# LiDAR Quality Assessment Report

MD-NRCS-LiDAR

# USGS NRCS Maryland LiDAR Project

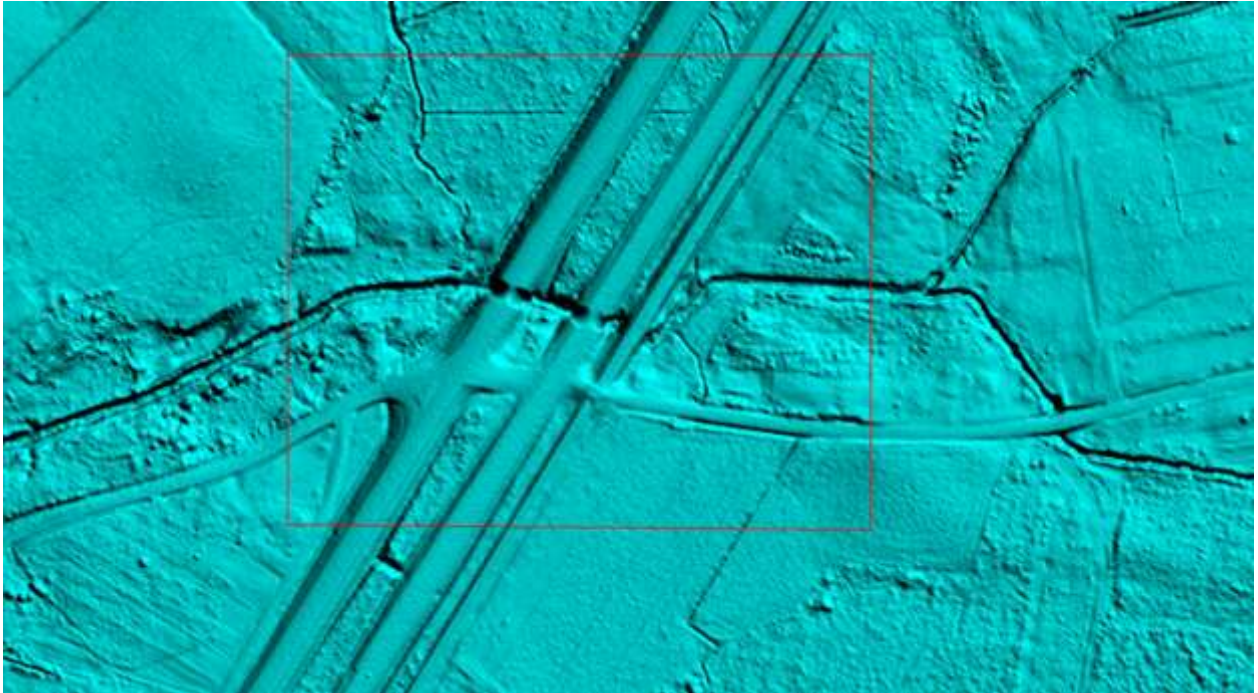
replace 2 culverts @ 38° 15' 40.4956" N, 75° 39' 57.3090" W  
CORRECTED

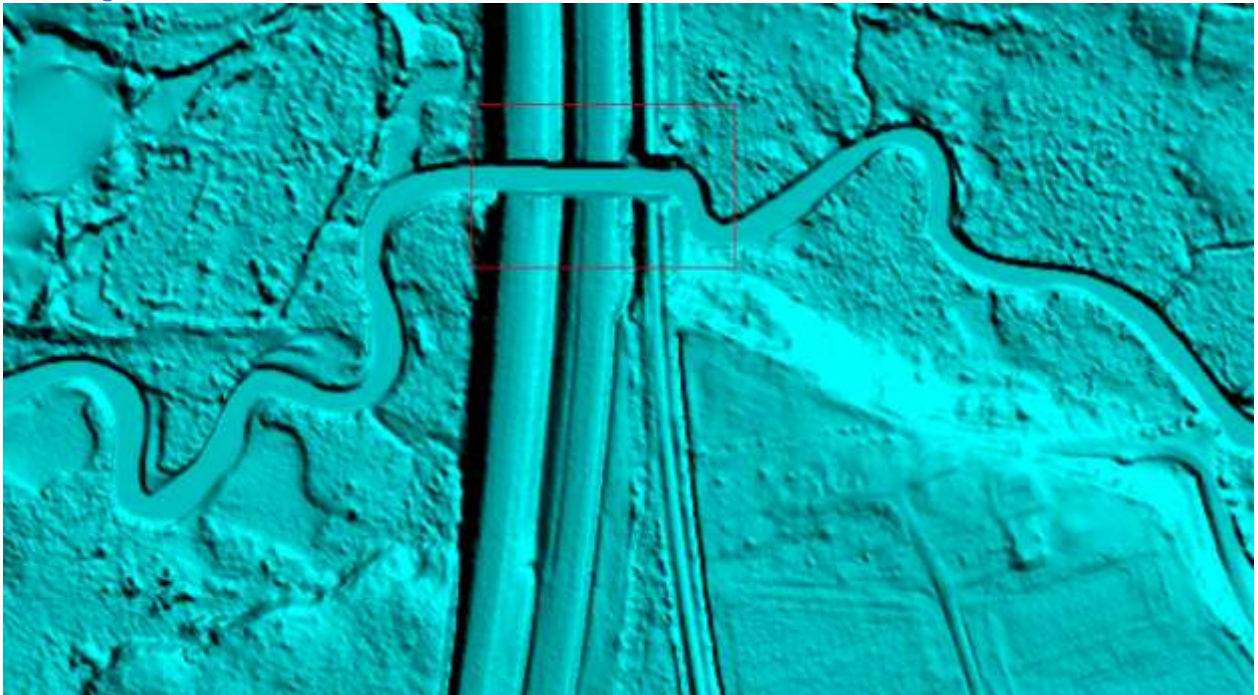
replace 3 culverts @ 38° 09' 55.3550" N, 75° 41' 20.5452" W  
CORRECTED

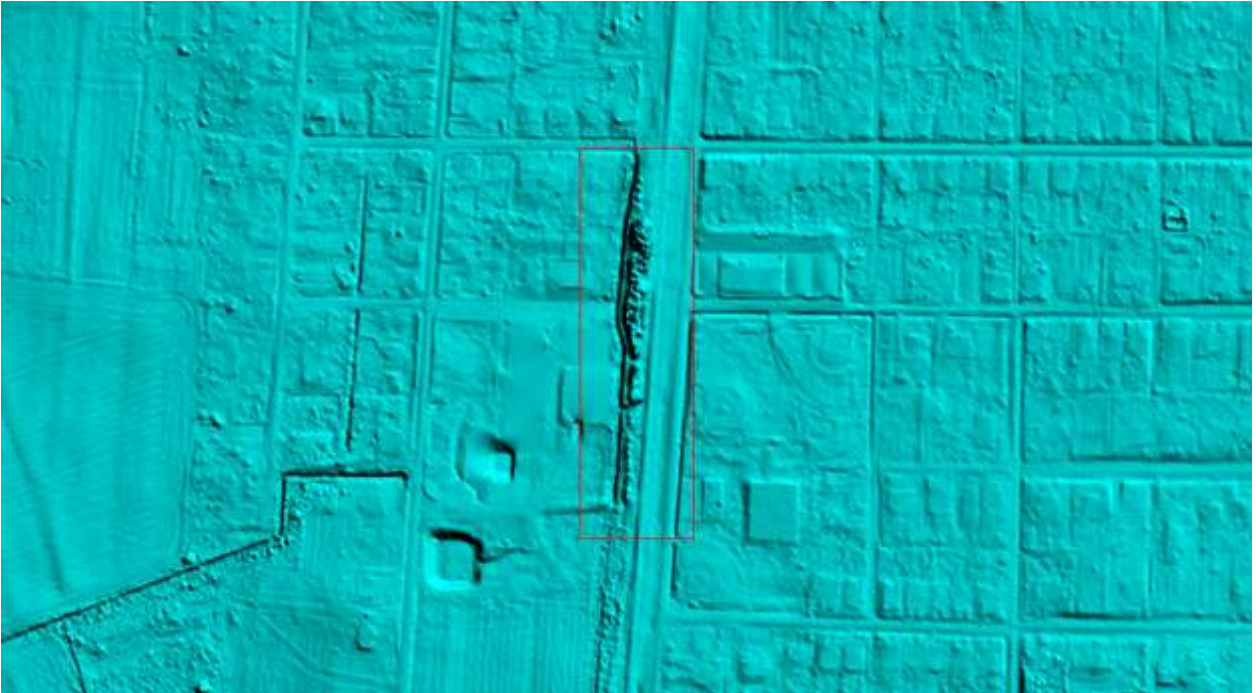
re-check possible classification error @  $38^{\circ} 27' 5.3547''$  N,  $75^{\circ} 34' 43.6359''$  W  
this example has been left to the discretion of the vendor.

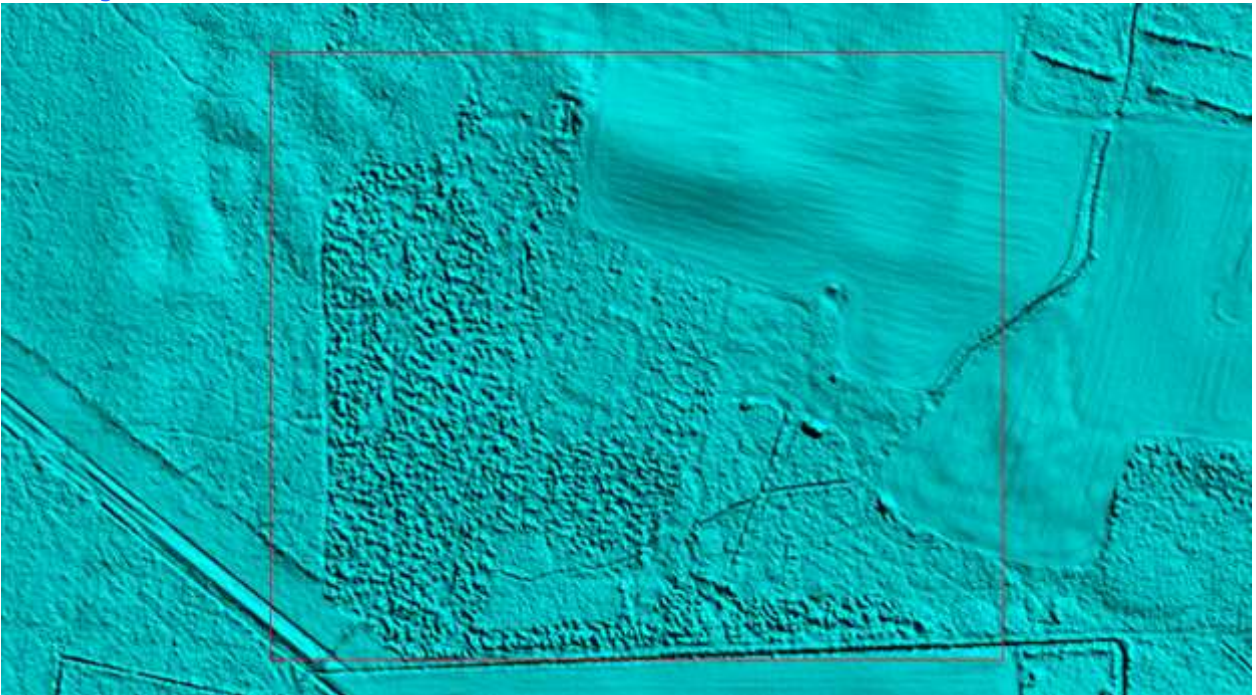
re-check possible classification error in forest @  $38^{\circ} 26' 15.8865''$  N,  $75^{\circ} 42' 55.0508''$  W  
this example has been left to the discretion of the vendor.
